MANOR PLANNING & ZONING
COMMISSION MEETING

AGENDA

105 E. EGGLESTON STREET
MANOR, TEXAS 78653
June 8, 2016 · 6:30 P.M.

Re: First Construction Plan and Final Plat Review for
Shadowglen Phase 2, Section 20 Subdivision
City of Manor, Texas

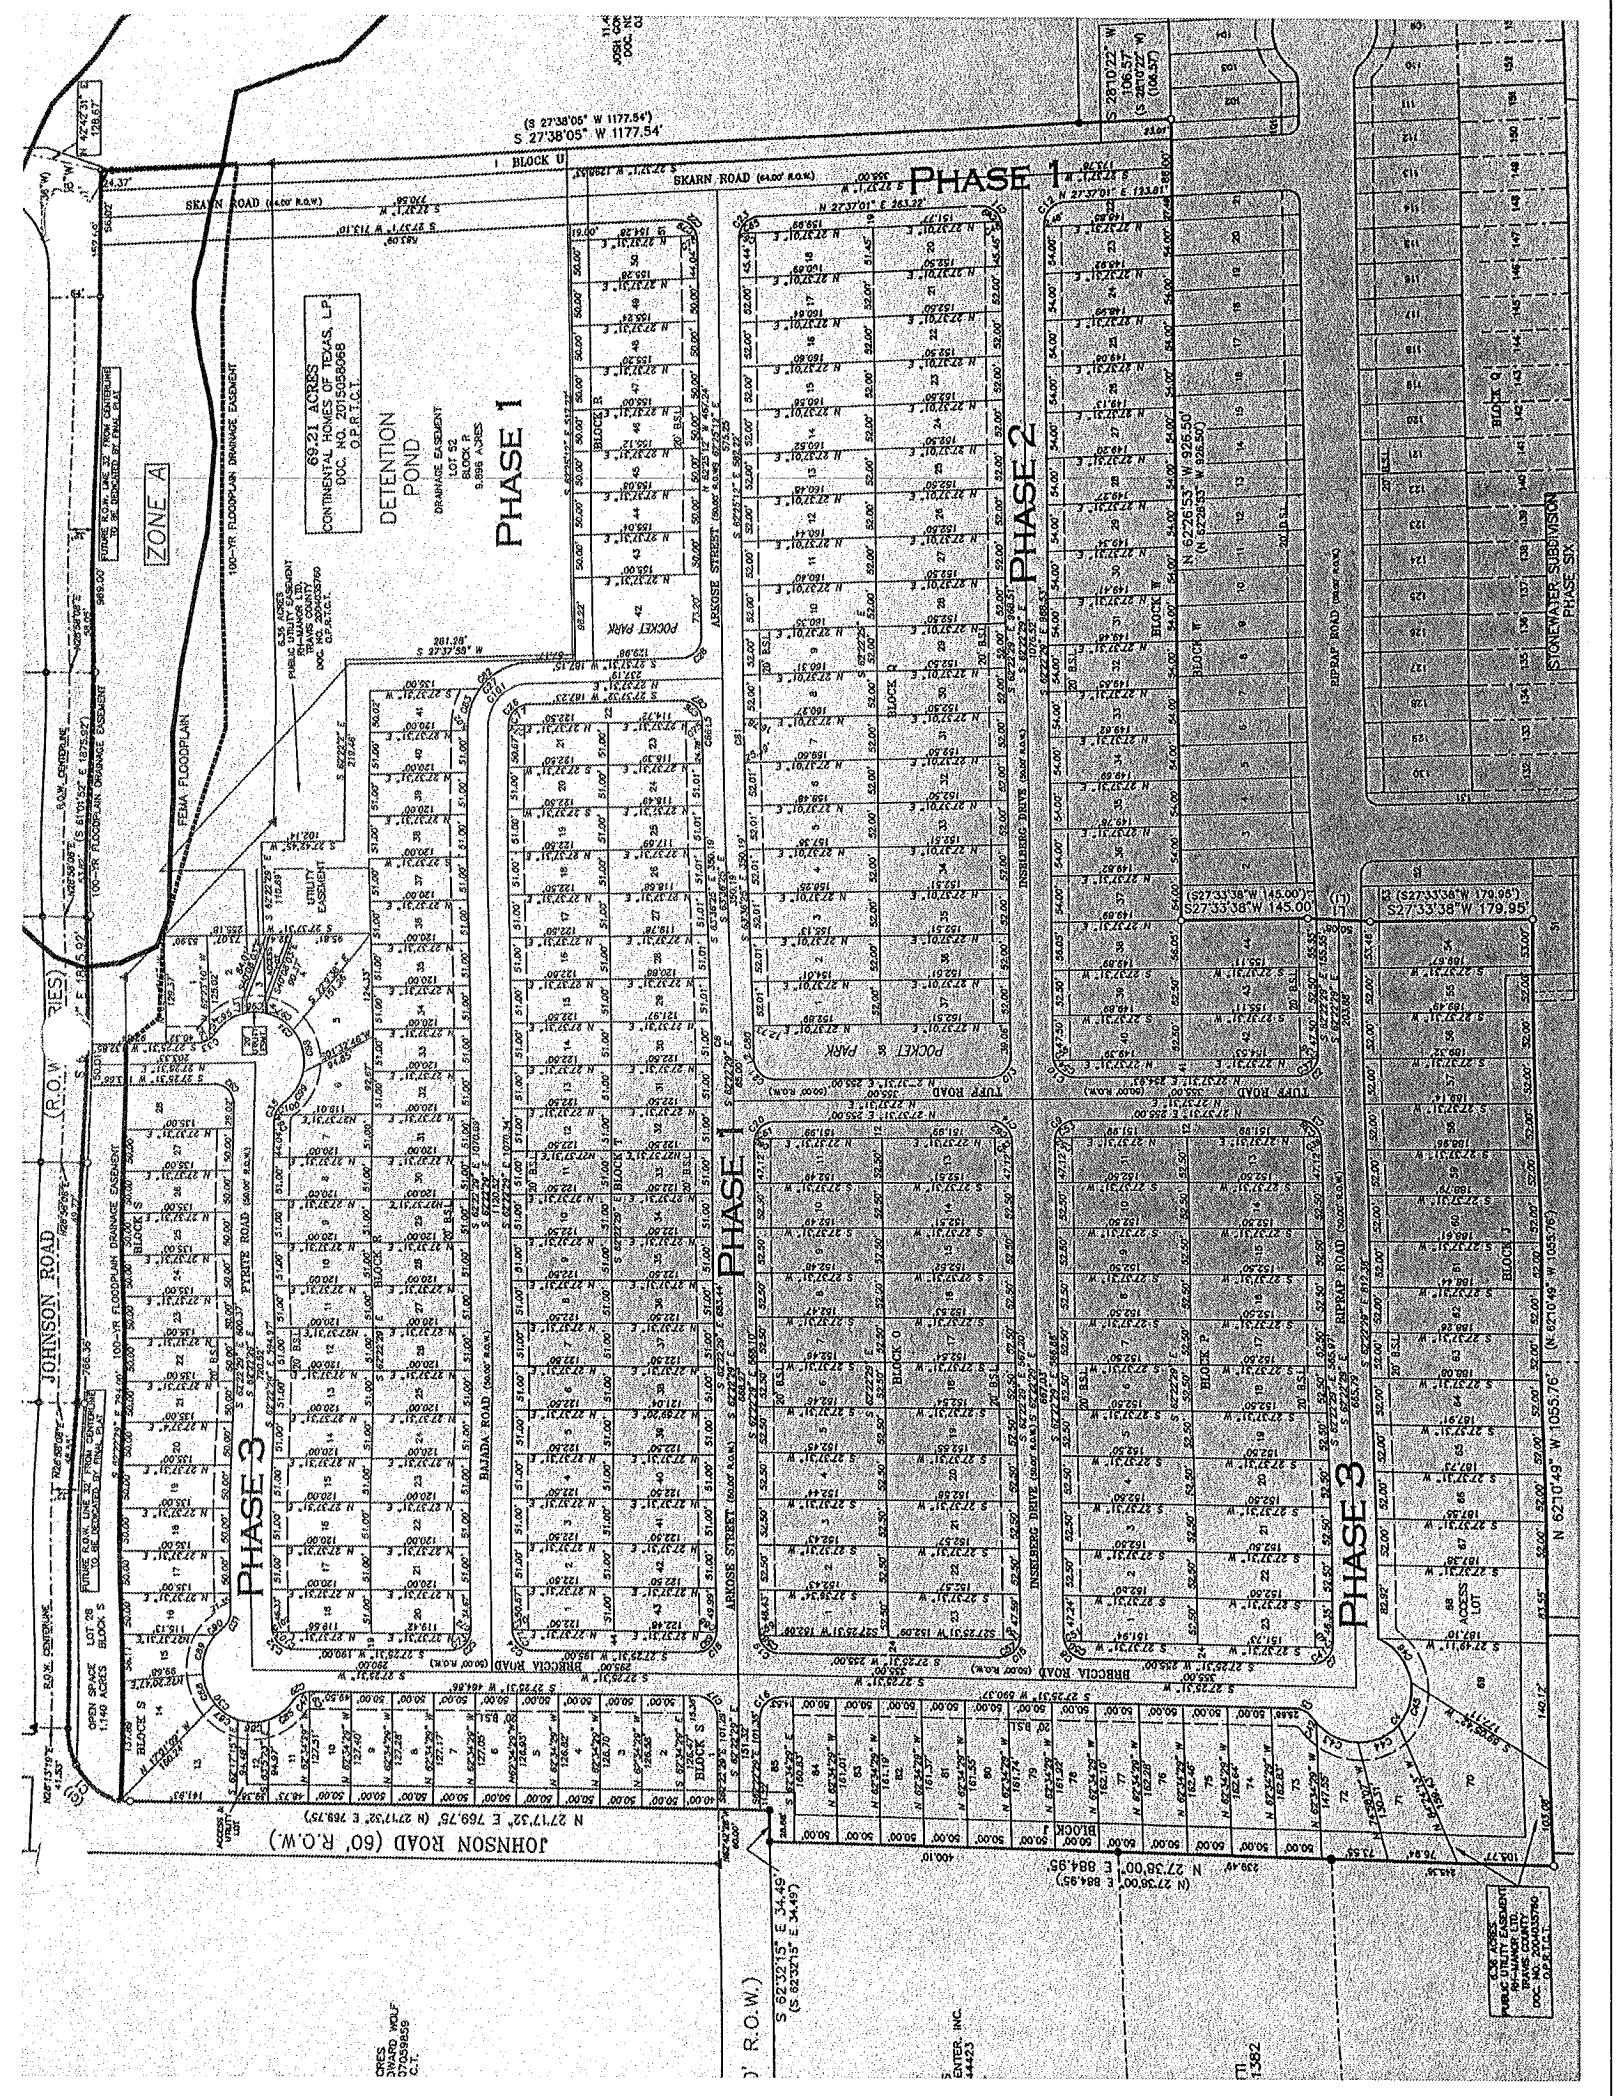
3. **Arkose Road should be stubbed out to the east to the adjacent property. The stubout is not shown on Sheet 2 – Stonewater North Preliminary Plat.**

4. **The alignment of Skarn Road should be revised to provide for a smoother tie in at the proposed intersection with Johnson Road. It appears the only change to the alignment was changing the R.O.W. and pavement widths.**

FINAL PLAT OF PRESIDENTIAL GLEN, PHASE 6

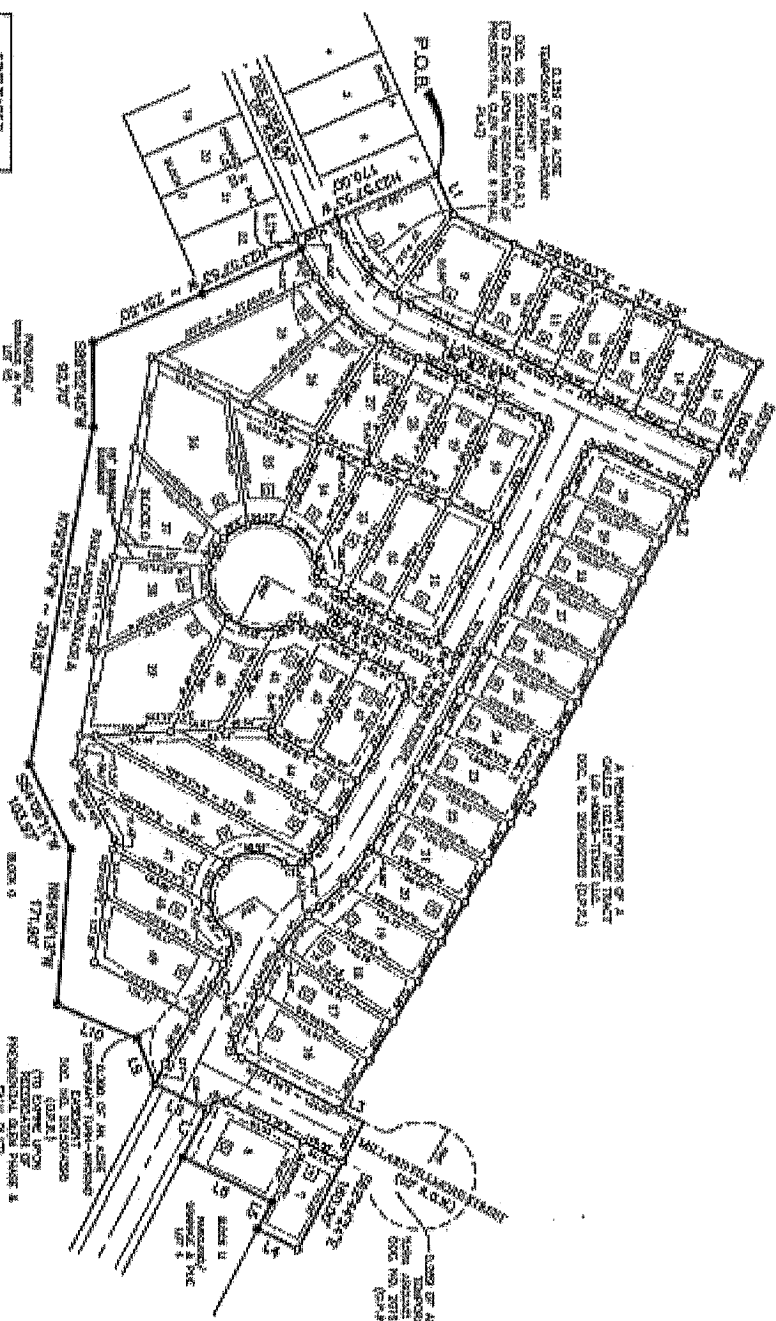
1. ~~Section 24(c)(3)(i) of Subdivision Ordinance 263B requires X and Y coordinates be identified for four (4) property corners on the plat.~~
2. ~~Provide approval from TCESD 12 for the proposed temporary turn around on Millard Fillmore.~~
3. ~~The deeds included with the submittal are not deed restrictions and covenants. According to the plat, the deed restrictions and covenants are recorded under Document 2007464897.~~
4. **Subdivision construction plans must be approved prior to final plat approval.**

Reference: Shadowglen Phase 2, Sections 17, 18, 21A, 21B, 24A & 24B Preliminary Plan

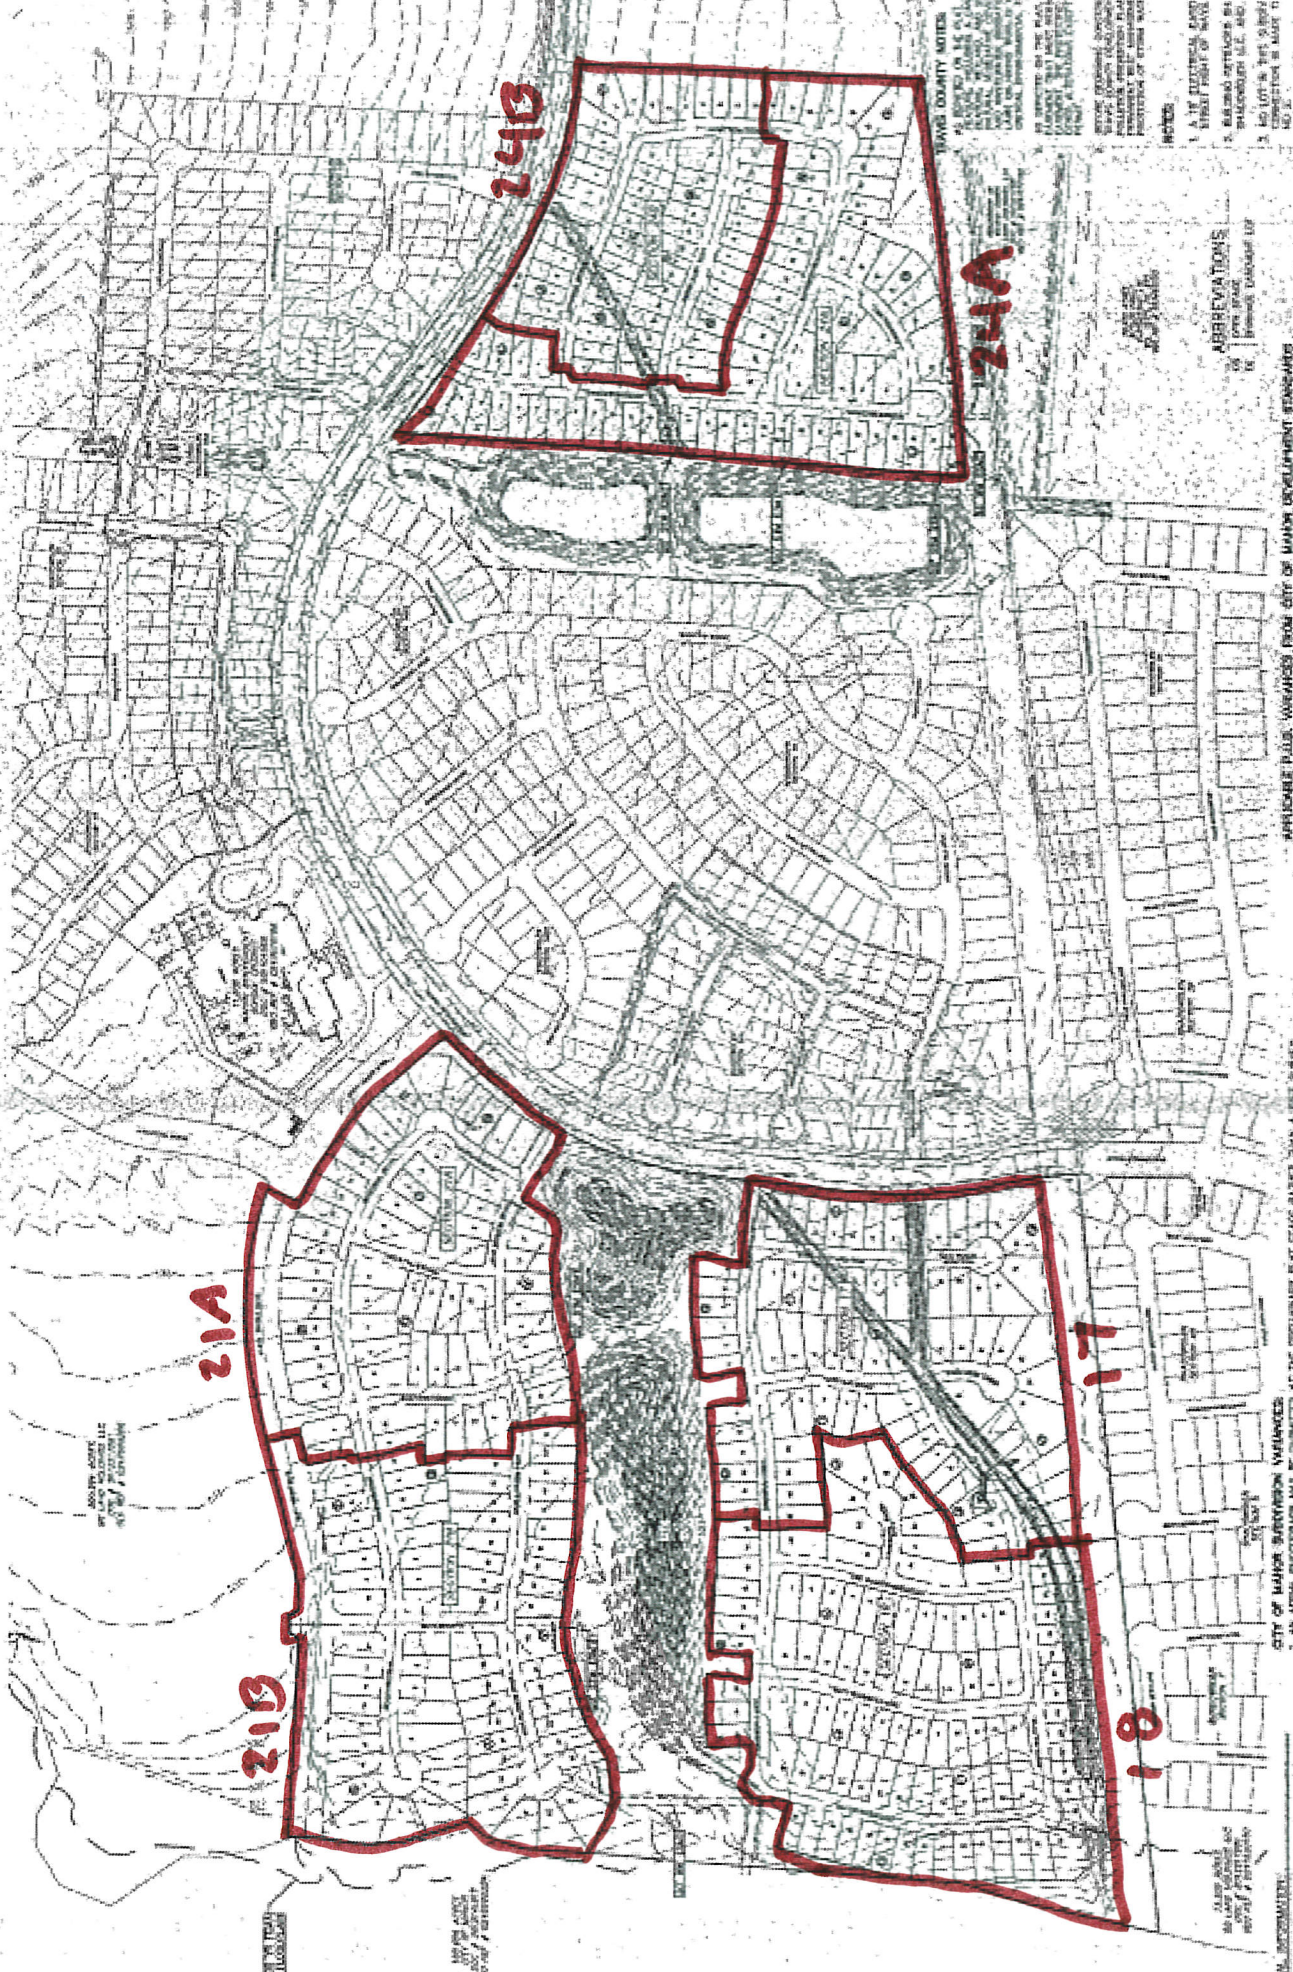
3. The existing ponds should be labeled on all sheets. Also, portions of Section 18 seem to be located within the floodplain. The floodplain should be clearly shown on the plan sheets. It is hard to distinguish where the floodplain is located.

4. The note on Sheet 2 regarding who will provide water and wastewater service to the proposed sections differs from the information provided in the summary letter.

5. Elevations should be labeled on all topography shown on the plan sheets.
6. The boundary of Section 21A is unclear on Sheet 4.
7. On Sheet 6 there are two Lot #2s listed for Block E under Section 21A & 21B, one of which seems to be fairly large.

8. On Sheet Exhibit C it is unclear where drainage areas O4, O5 and O6 drain to.
9. The STM easements should be clearly shown on Exhibit C.
10. On Exhibit E the existing storm sewer outlet to the pond should be shown.
